Well Name: JAMES RANCH UNIT DI 1	Well Location: T22S / R30E / SEC 21 / SWNE / 32.3809943 / -103.8824303	County or Parish/State: EDDY / NM
Well Number: 164H	Type of Well: OIL WELL	Allottee or Tribe Name:
Lease Number: NMNM0300	Unit or CA Name: JAMES RANCH UNIT	Unit or CA Number: NMNM70965X
US Well Number: 300154262700X1	Operator: XTO PERMIAN OPERATING LLC

Type of Submission: Notice of Intent	Type of Action: Plug and Abandonment
Date Sundry Submitted: 05/09/2024	Time Sundry Submitted: 10:42
Date proposed operation will begin: 05/23/2024

PLUG AND ABANDON WELLBORE
JAMES RANCH UNIT DI 1 164H
EDDY COUNTY, NEW MEXICO
Class II

Action 343691

JRU DI 1 164H- Proposed WBD

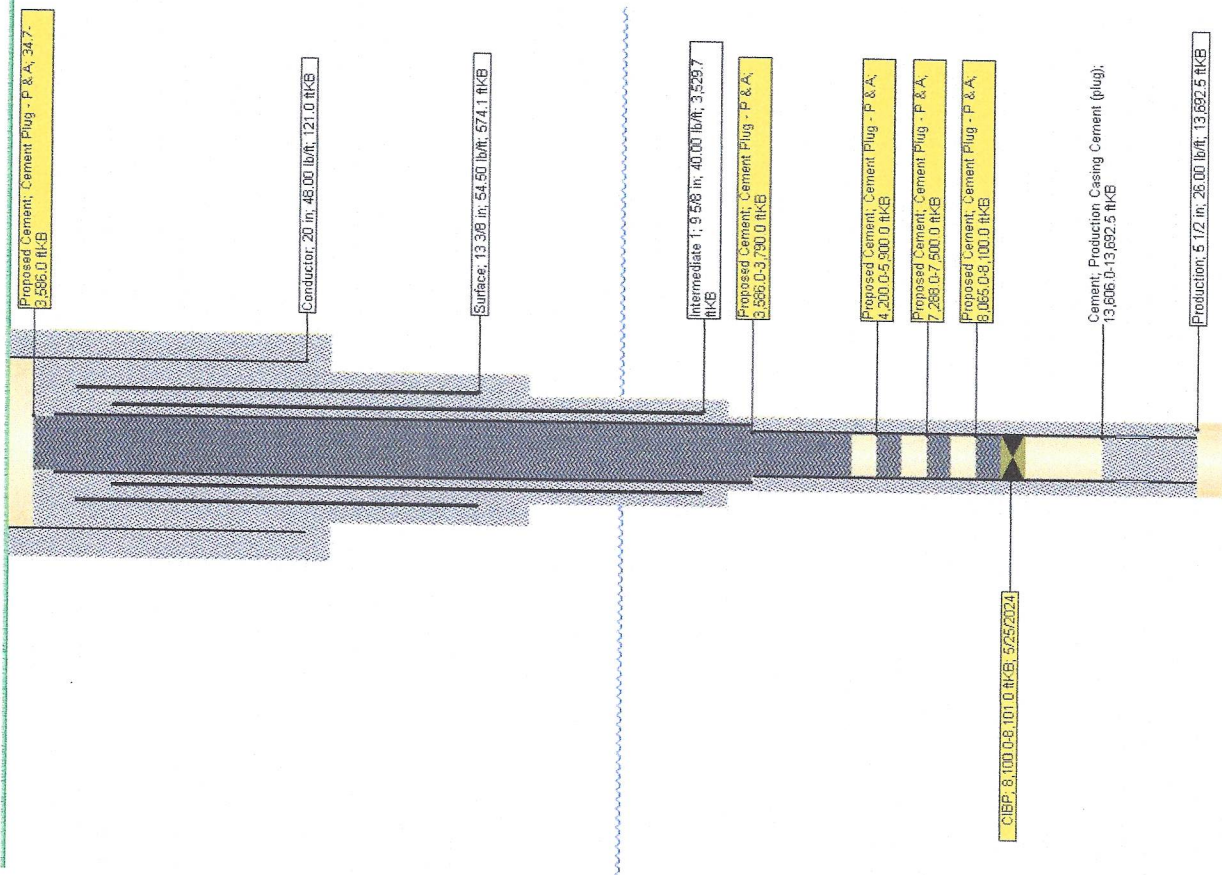
- 1) MIRU plugging company. Set open top steel pit for plugging.
- 2) POOH LD rods and pump.
- 3) ND WH and NU 3K manual BOP. Function test BOP.
- 4) MIRU WLU, RIH GR to 8130'; RIH set CIBP (5-1/2", 20# csg) at 8,100', pressure test to 500 PSI for 30 minutes; dump bail 35' **Class H** cement from 8,100' to 8,065'. WOC and tag to verify TOC. (KOP) *or spot 25 SKS on top.*

- 5) Spot ³²~~25~~ SKS **Class H** cement from 7,500' to ^{7230'}~~7,288'~~. WOC and tag to verify TOC. (T/Bone Spring)
- 6) Spot 170 SKS Class C cement from 5,900' to 4,200'. WOC and tag to verify TOC. (T/Brushy Canyon, T/Cherry Canyon)

9.625 inch- Shoe Plug	3473.41	3609.00	135.59	Tag/Verify	358.00	C	Spot cement from 3790' to surface. Verify at surface.
				If solid base no need to Tag (CIBP present and/or Mechanical Integrity Test), If Perf & Sqz then Tag, Leak Test all CIBP if no Open Perforations			
Spacer Plug @ 5850	5741.50	5900.00	158.50		25.00	C	Spot cement form 5900' to 5741'.
				If solid base no need to Tag (CIBP present and/or Mechanical Integrity Test), If Perf & Sqz then Tag, Leak Test all CIBP if no Open Perforations			
Bonesprings @ 7354	7230.46	7404.00	173.54		32.00	H	Spot cement from 7500' to 7230'.
KOP @ 8100	7969.00	8150.00	181.00	If solid

If solid base no need to Tag (CIBP present and/or Mechanic al Integrity Test), If Perf & Sqz then Tag, Leak Test all CIBP if no Open Perforatio ns			
CIBP Plug	8065.00	8100.00	35.00	ns	25.00	H	Set CIBP at 8100'. Leak test CIBP. 25 sxs on top.
5.5 inch- Shoe Plug	19273.81	19569.00	295.19	Tag/Verify
